NEW AND IMPROVED

MTS 2-TON SERVICE CRANE BODY

IMPROVED REAR BODY ACCESS & FUNCTIONALITY:

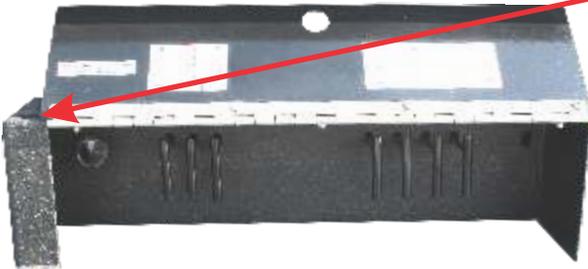
- Additional & larger handles are now standard.
- Improved rear access step.
- Rotated air reel door latch 180 degrees.
- Improved tailgate chain sleeves to braided mesh.
- Modified (2) rear safety chain hook location.
